SUNDRY NOTICES AND REPORTS ON WELLS

San Juan 31-6 Unit

Re: Permanent Abandonment

Well: 3 San Juan 31-6 Unit.

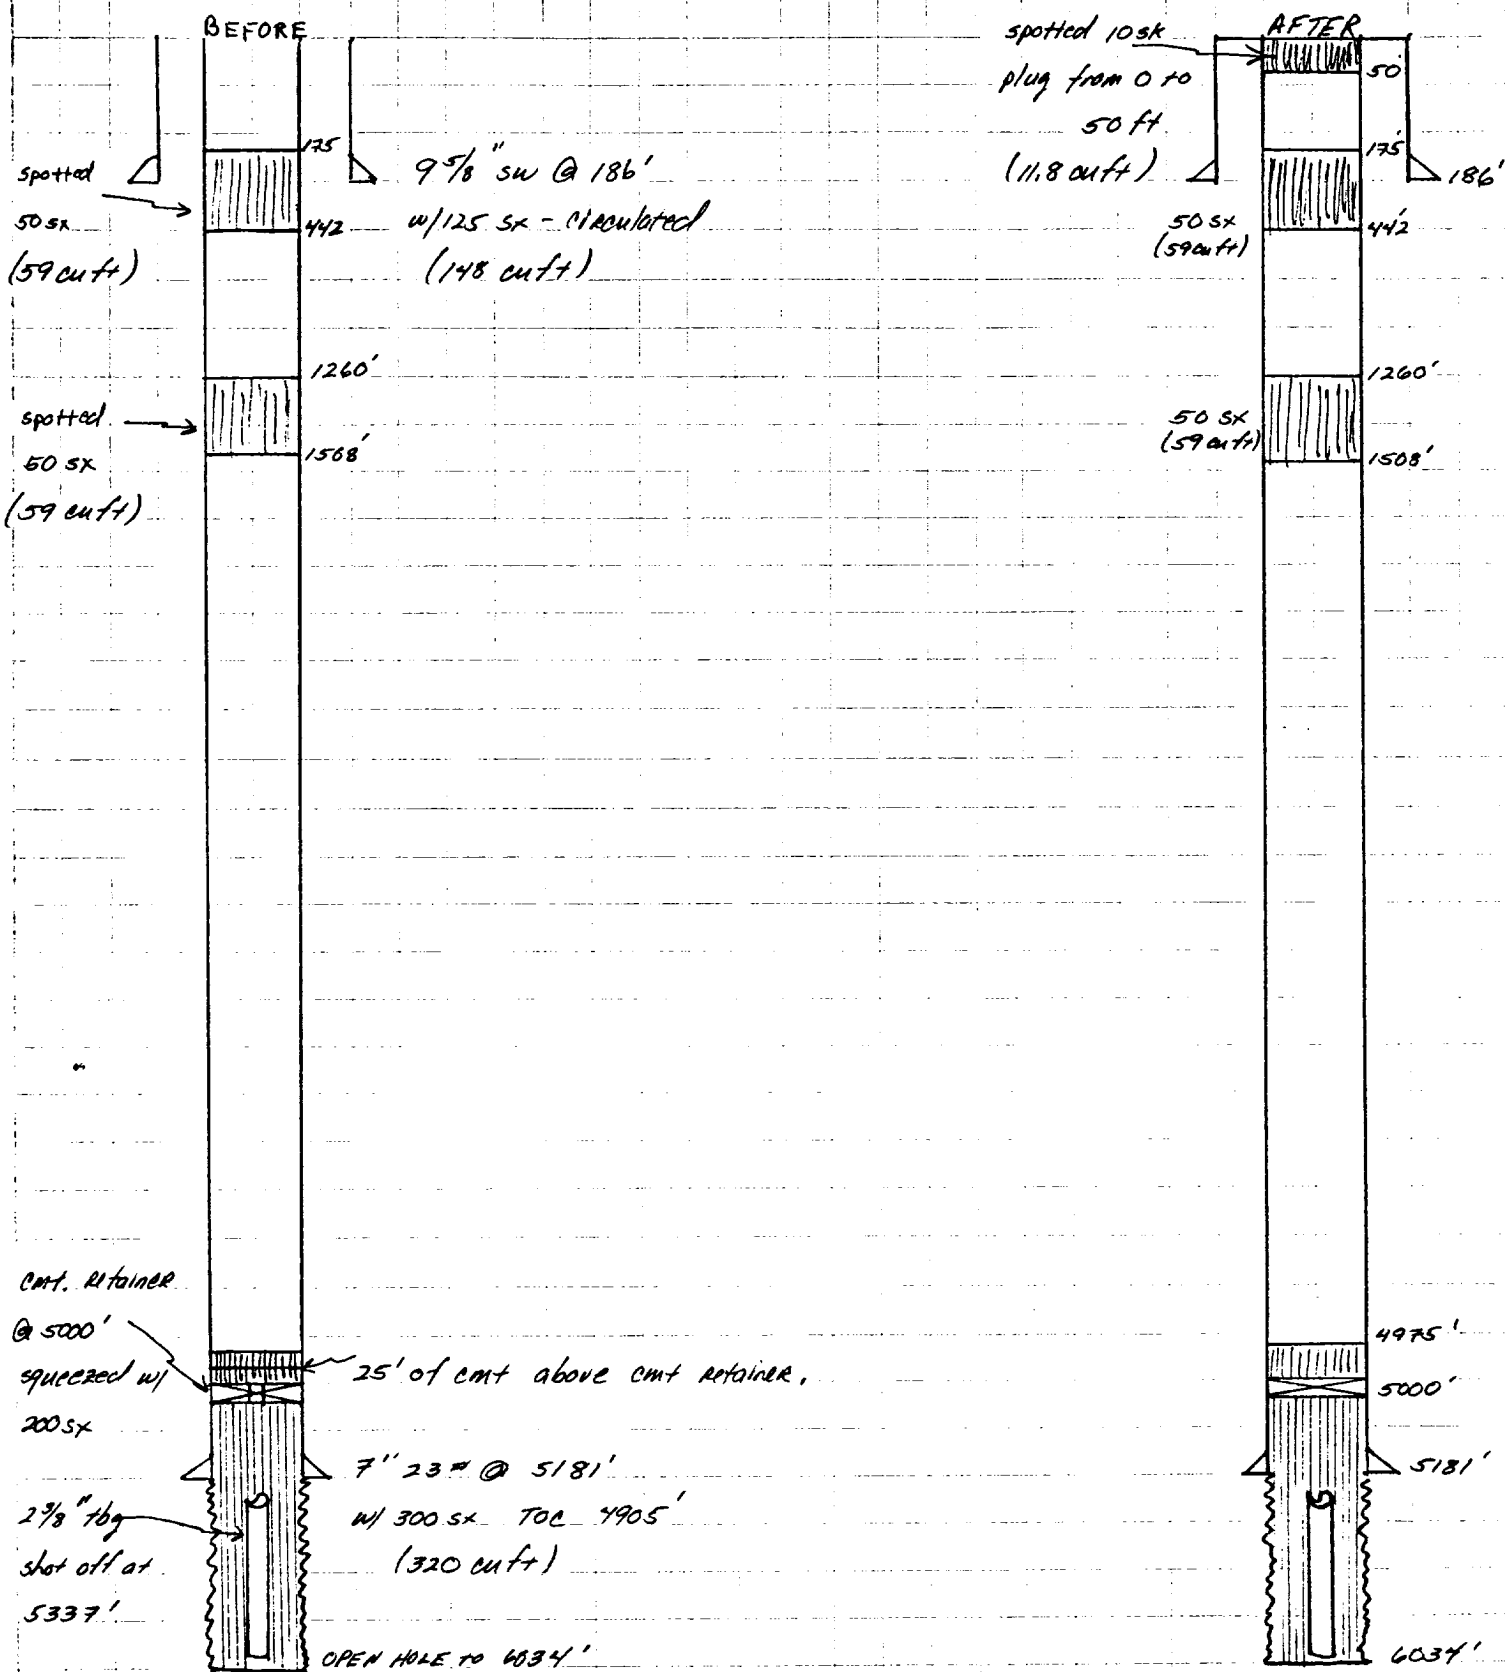
*Place cement outside the 7" casing from  
275' to 175' (by pumping down the annulus  
between the 7" and 9 5/8" casing).*
